Residential Subdivision, Lot 1 DP 1097743, Pacific Highway, Moonee Beach, Coffs Harbour Local Government Area (SSD 7198, formerly MP 09\_0067)

Comment on the Response to Submissions Report

**Figure 1:** Difference between MHWM and HAT as commencement points for the buffer to Moonee Creek estuary

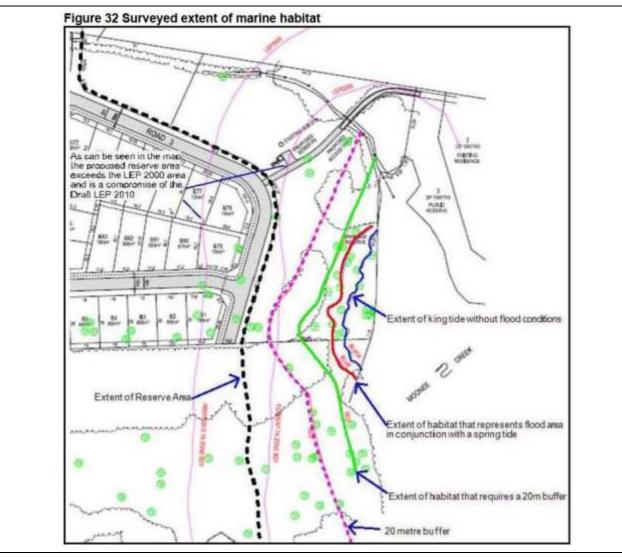
Measuring the proposed 64 – 85 metre buffer from the outer edge of the tidal zone, ie the Highest Astronomic Tide (HAT) is required to ensure the whole of the wetland is actually afforded protection by the buffer. The present proposal for a buffer that commences from the intertidal zone behind a stand of mangroves (Figure 1), approximating the Mean High Water Mark (MHWM). The outcome is that the buffer intersects the intertidal wetland itself. Approximately half of all high tides will extend beyond the MHWM. The edge of the estuary is generally considered to include up to the Highest Astronomic Tide. It is DPI Fisheries view that the HAT was the commencement point for the 100 metre buffers proposed in the Moonee Beach DCP and the Moonee Estuary Management Plan.

A further consequence of the present proposal is that areas of TYPE 1 (Highly Sensitive) Key Fish Habitat such as saltmarsh will not be fully protected by the buffer. In the subject proposal an area of intertidal habitat approximately >100m² occurs within the buffer itself rather than being surrounded and protected by it. It warrants noting that Figure 32 of the Concept Plan presents maps that concur with DPI Fisheries' assessment of the marine/estuarine habitats (*Surveyed extent of Marine Habitat in JW Planning Pty Ltd Part 3A Concept Plan Environmental Assessment – Pacific Highway Moonee (MP09\_0067) June 2013 Page 59 of 120*) in contrast to the buffer edge proposed in the subject proposal. I have included a scanned image of the JW Planning map as Figure 2.

- A buffer of 50-100 metres should be provided as measured from the highest astronomical tide.
- It is important that the level of stormwater treatment during both construction and operation of the development is of a standard that does not compromise key fish habitats or the values of the Solitary Islands Marine Park.
